John Pugh FRICS Chartered Building Surveyor, Conservation Consultant  
 Bryn Coch Farm, Llanfair DC, Ruthin, Denbighshire, LL15 2SH Tele 01824 703074  
 73A ERW GOCH RUTHIN DENBIGHSHIRE LL15 1RS  
 FOR MRS. M MOSFORD  
 NEW HOUSE  
 ELEVATIONS  
 Drawn Scale 1:100@A3 Date 05.2020 Status Draw No 473/04

**APPLICATION NO:** 02/2020/0811/ PF

**PROPOSAL:** Erection of a detached dwelling, construction of a new vehicular access and associated works

**LOCATION:** Land at (Part Garden of) 73A Erw Goch Ruthin LL15 1RS

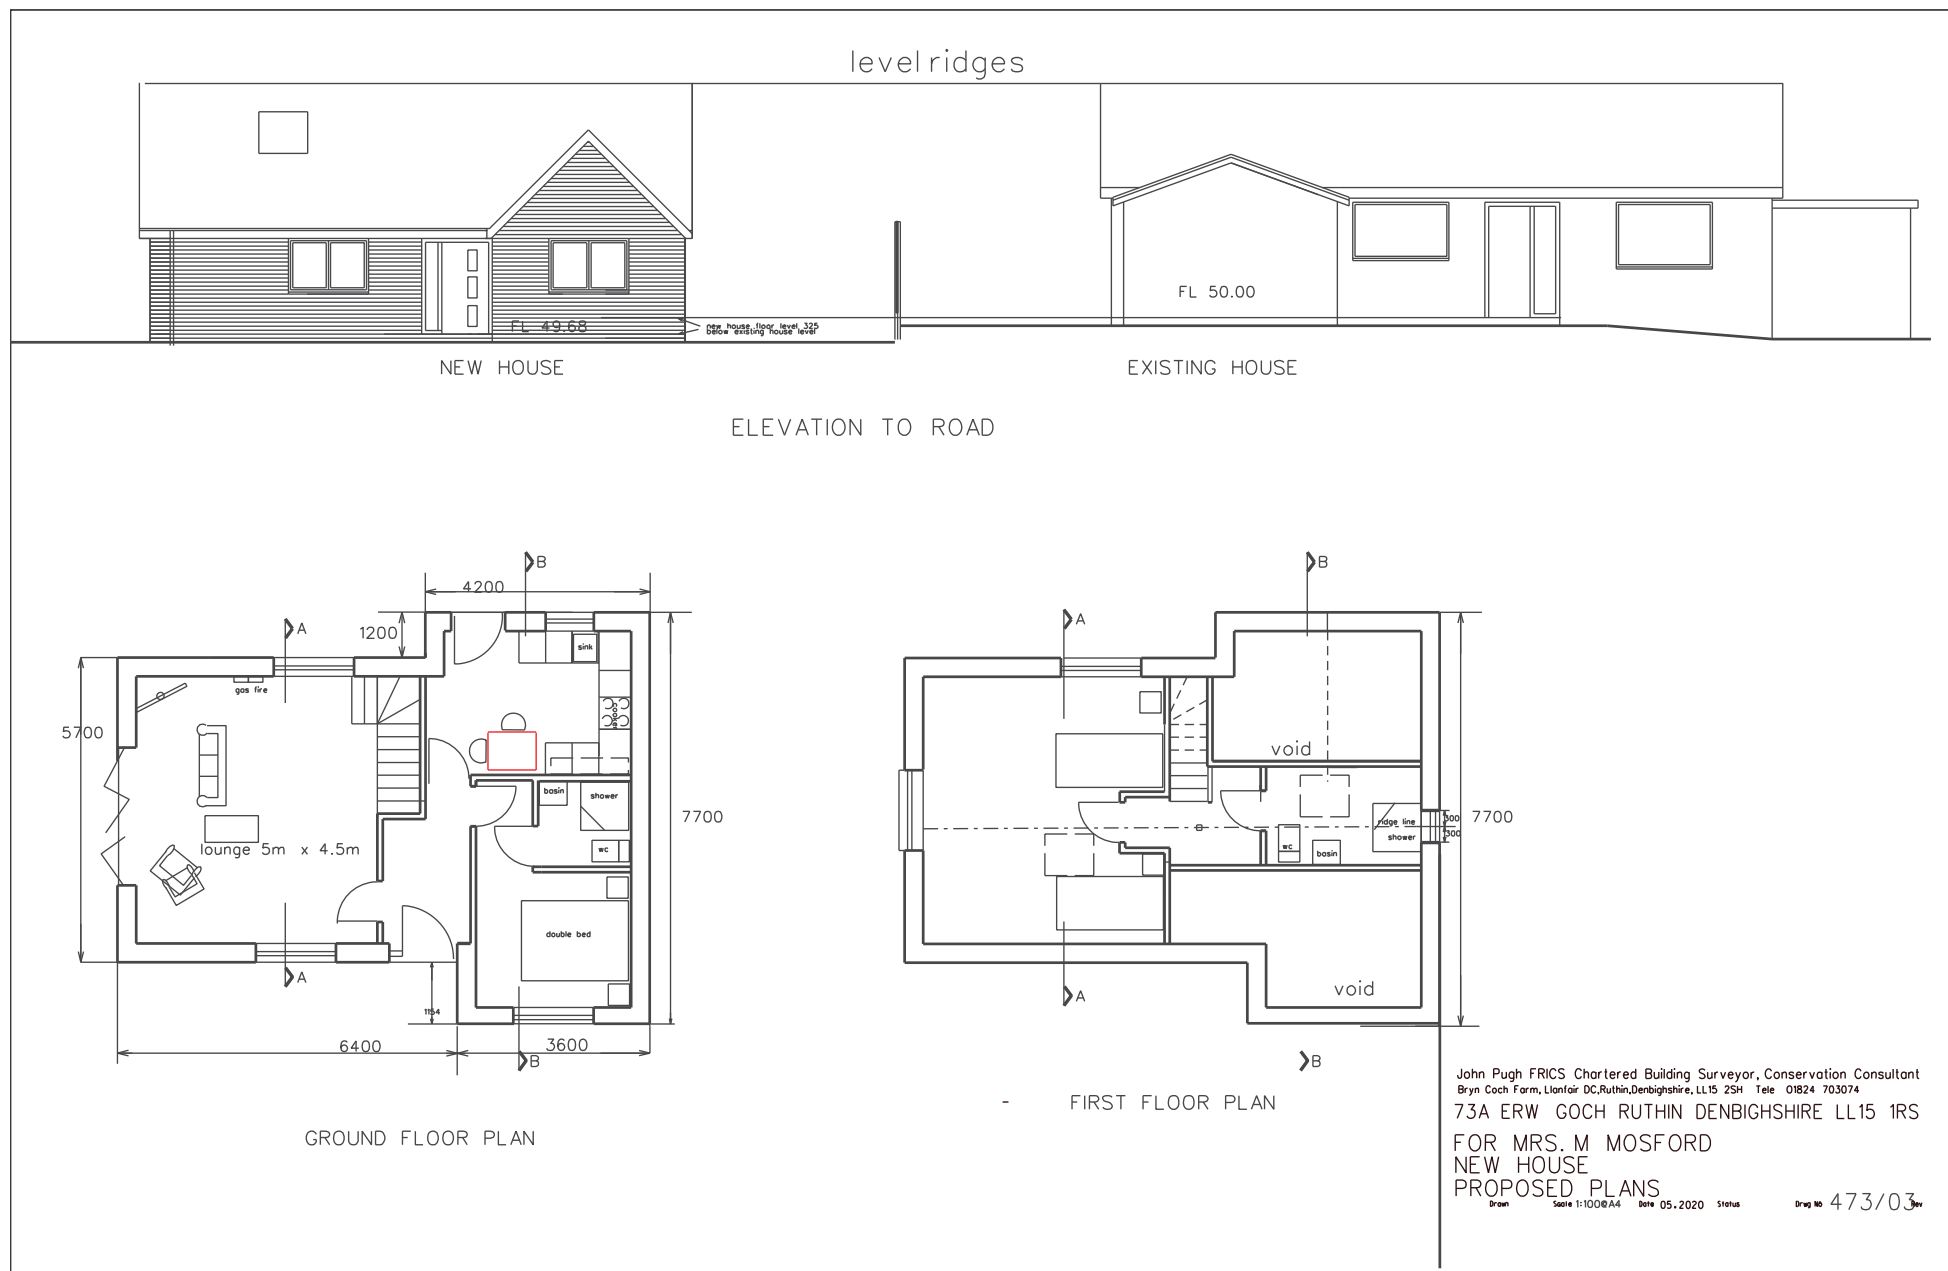
To conclude, it is considered that owing to its height and siting in relation to the adjacent bungalows, and its distance to the highway, the proposal would appear cramped and obtrusive within the street-scene. It would not be in keeping with the character of the area. It is therefore concluded that the development is in conflict with Policy RD 1 in regard to visual amenity as the scheme would unacceptably detract from the character and appearance of the area and as such is contrary to the guidance set out in the Residential Development Supplementary Planning Guidance document.

1. It is the opinion of the Local Planning Authority that the proposed dwelling would, by virtue of its siting and height in a prominent location within the residential estate, have an adverse visual impact on the open character and appearance of the estate. The proposal is therefore considered to be in conflict with criteria i) of Policy RD1 of the Denbighshire Local Development Plan, guidance contained within the Residential Development Supplementary Planning Guidance Note and Planning Policy Wales (Edition 11).

*View of proposed dwelling heading down Erw Goch towards Ruthin.*

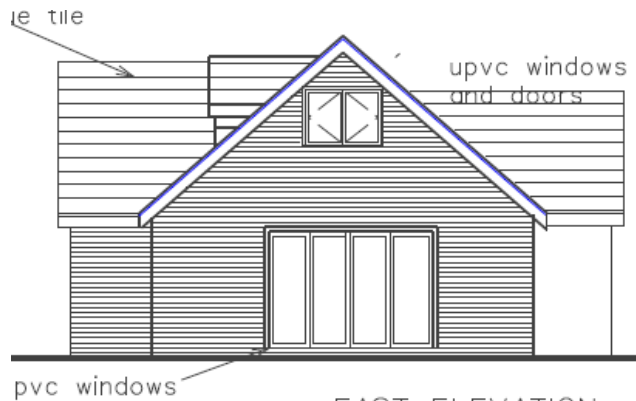
The existing dwellings on this side of the road are all set back from the pavement approximately more than 2.5m. The proposed dwelling would be set back by 1.7m (at its nearest) from the pavement. It is considered that this would lead the development to appear cramped in the plot and out of character with the existing building lines of development in the area.
